UCM Series IP PBX Firmware Release Notes

FIRMWARE VERSION 1.0.15.13

UCM6301, UCM6302, UCM6304, UCM6308, UCM6300A, UCM6302A, UCM6304A, UCM6308A

06/13/2022

Figure 3 - Auto Record Video & Screen Share Only

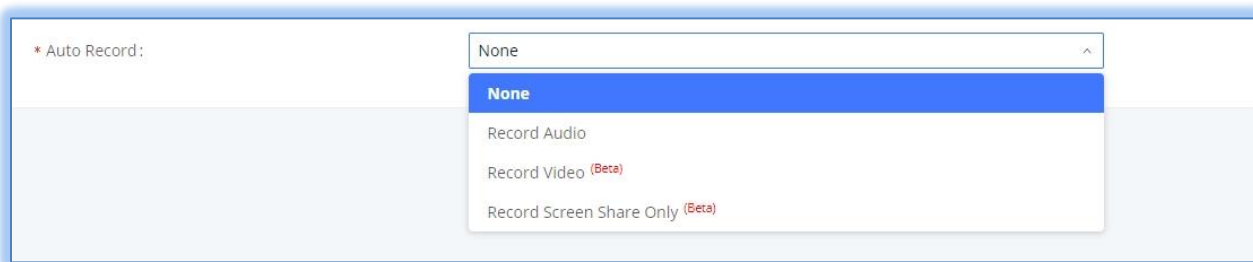
Users can now set meeting rooms and scheduled meetings to automatically record video meetings and screen share only.

Figure 4 - SYN and Ping Flood Protection

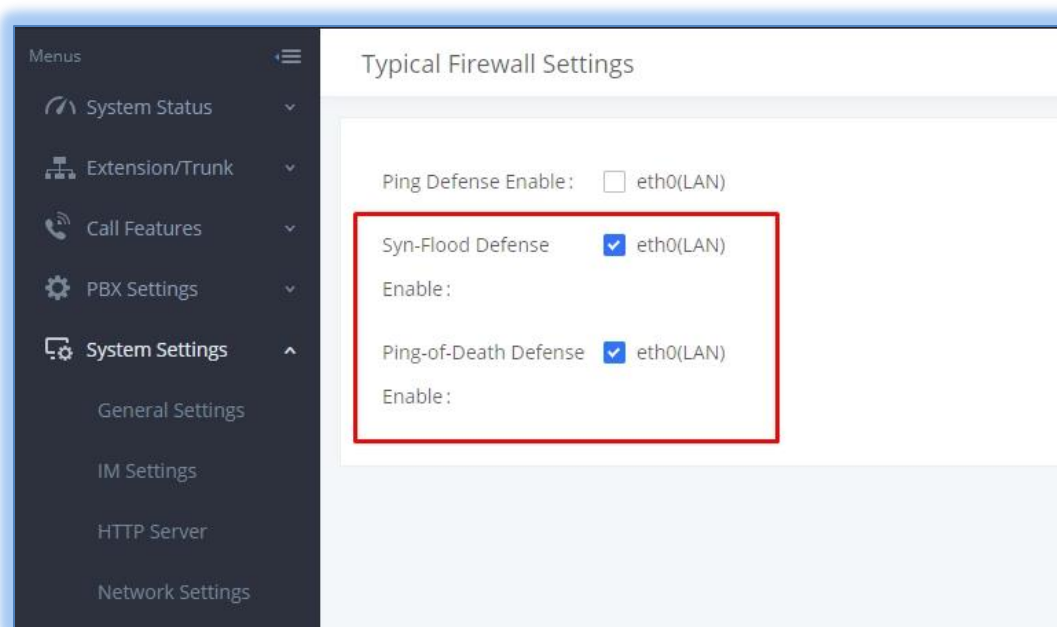
The UCM will now generate alerts notifying users when the flood defense protections have been triggered against malicious attacks. Currently, the UCM offers protection against SIP, SYN, and ping floods. SYN flood and ping flood protection can be toggled from the *System Settings*→*Static Defense*→*Typical Firewall Settings* page.

Figure 5 - SIP Flood Protection

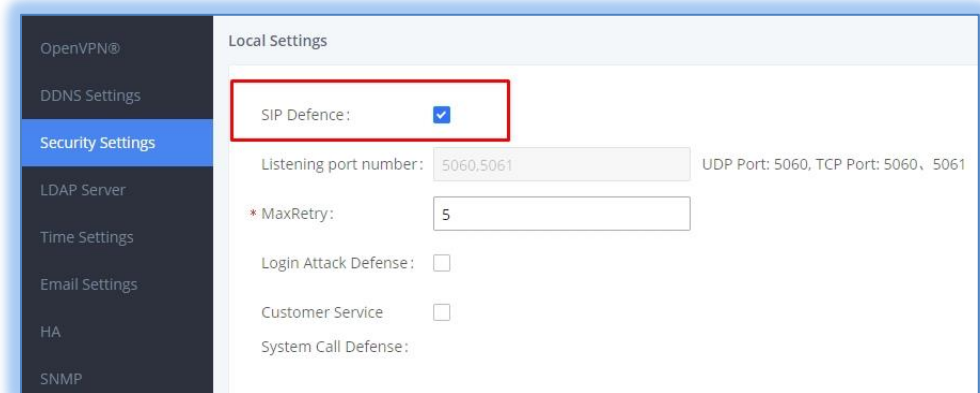
For SIP flood protection, the option can be enabled under the *Fail2ban* page. This option was previously called *Asterisk Service*.

To account for this change, SIP flood alerts will not trigger the Fail2ban blocking alerts alongside it to avoid redundant notifications.

Figure 6 - System Events Flood Attacks

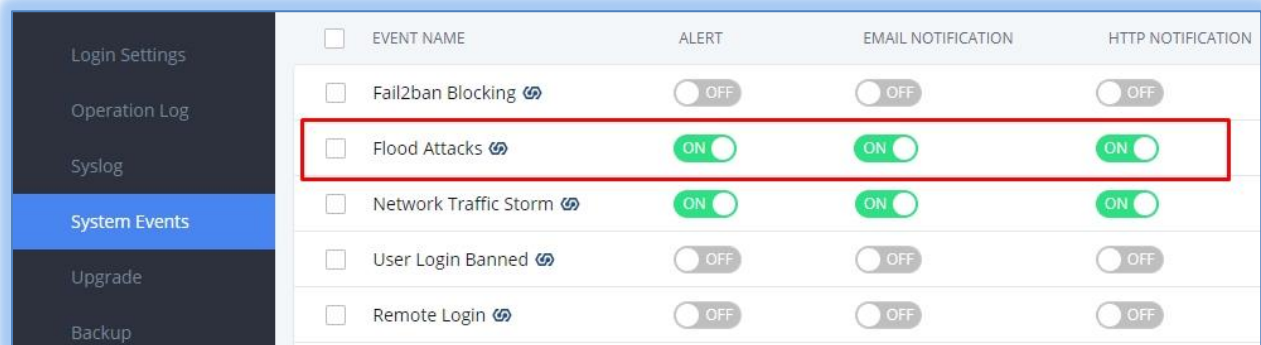
Once these have been enabled, users can then enable alert generation and notifications in the *System Events* → *Alert Events List* page.

Figure 7 - Network Port Traffic Control

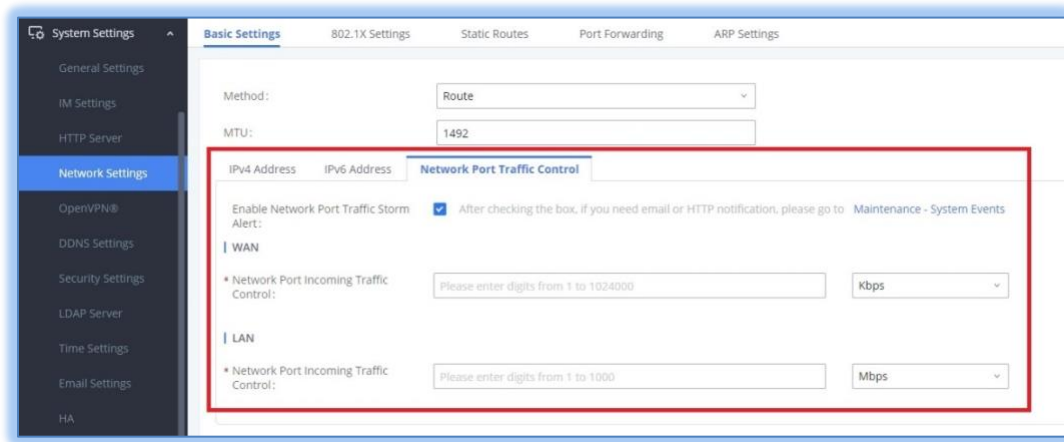
The UCM can now monitor its network ports for excessive traffic and generate system event alerts when the data rate exceeds a specified threshold. Different interfaces will be available depending on what network method is used.

- *Route* - Both LAN and WAN ports can be configured.
- *Switch* – Only the LAN port can be configured.
- *Dual* – Both LAN1 and LAN2 ports can be configured.

Figure 8 - Network Port Traffic Control Alerts

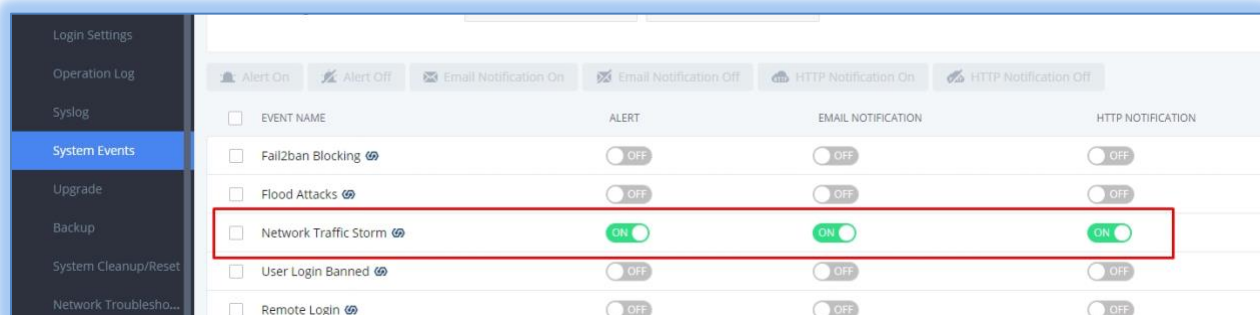
To toggle the alert and configure email and/or HTTP notifications, users will need to go to the *Maintenance*→*System Events* page and toggle on the *Network Traffic Storm* switches.

Figure 10 - SNMP Settings

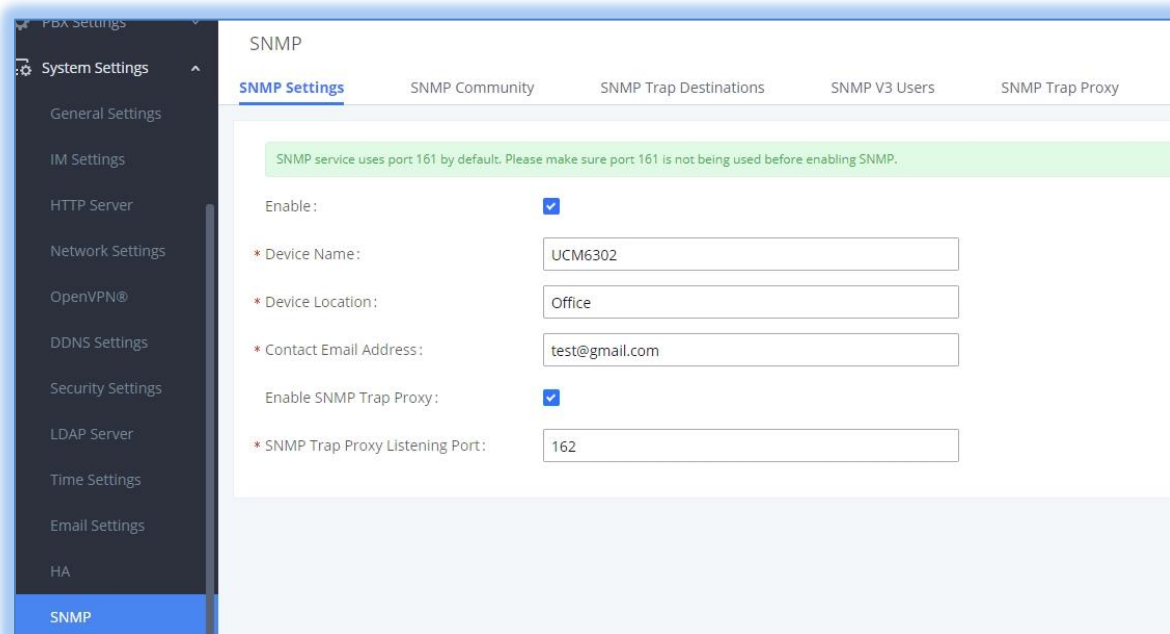
SNMP is now available and can be configured from the *System Settings* → *SNMP* page.

SNMP service uses port 161 by default. Please make sure port 161 is not being used before enabling SNMP.

Figure 11 - SNMP Community

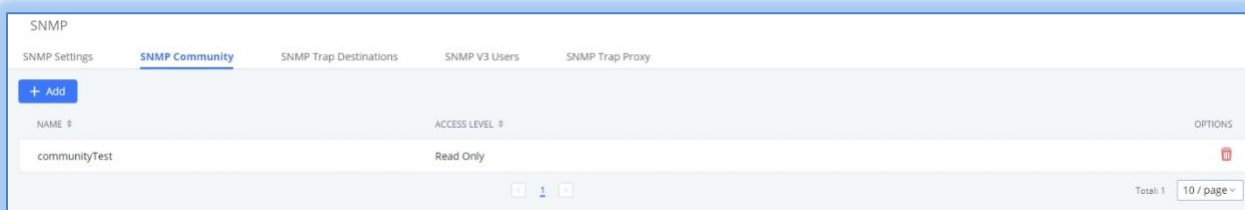
The SNMP Community page allows users to configure the UCM63xx's community strings, allowing it to determine whether or not to respond to SNMP requests from clients. Only *Read Only* access level is available.

Figure 16 - WebRTC Trunks

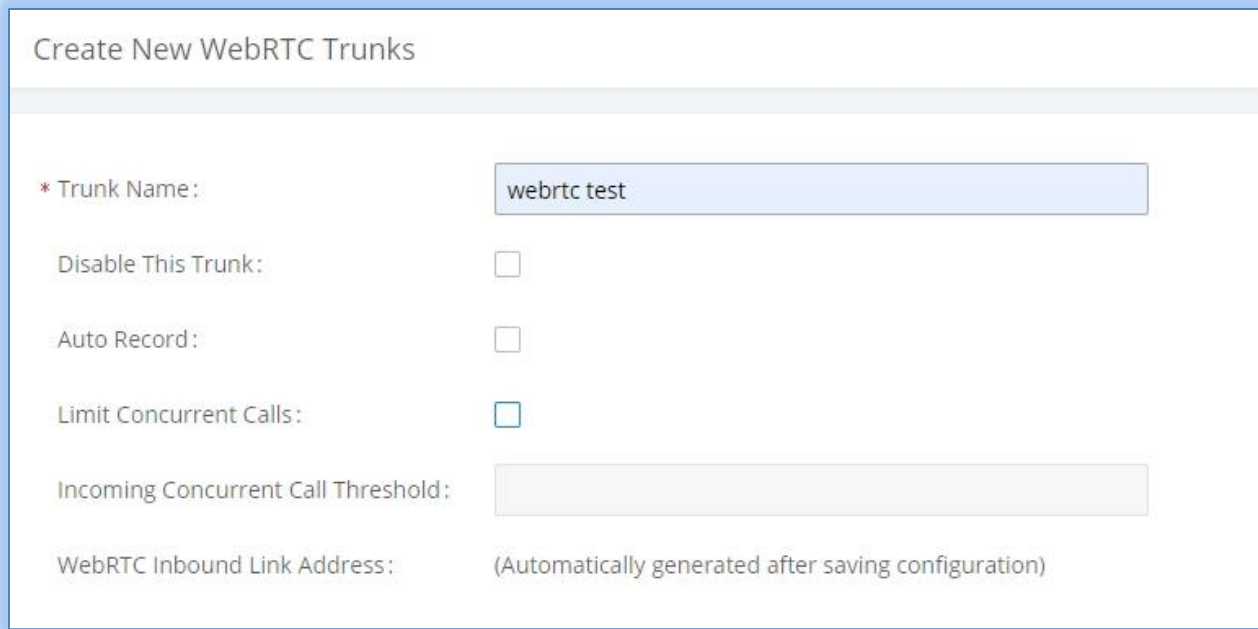
A new type of trunk is now available for users to configure. WebRTC trunks allows people to dial into the UCM from automatically generated URLs to specified destinations on the UCM via inbound routes. This can be hyperlinked on business websites to allow people to quickly and conveniently contact companies.

Figure 17 - WebRTC Trunk Overview

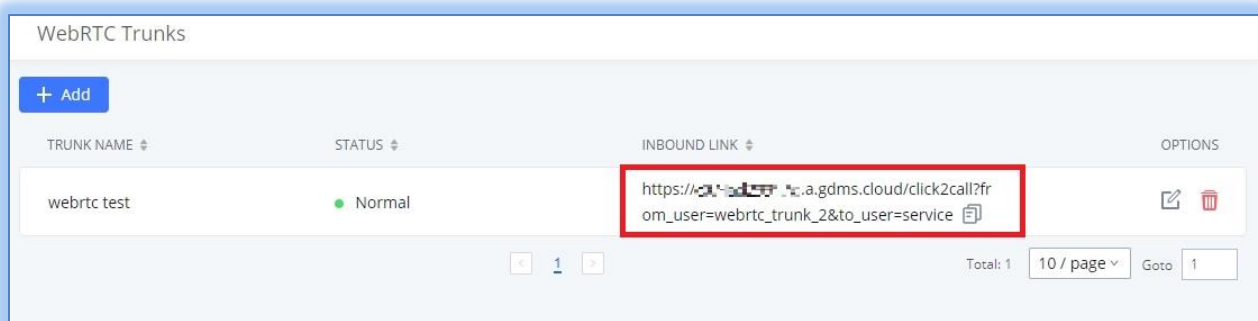
Once created, the URL will be automatically generated and displayed on the WebRTC trunk overview page.
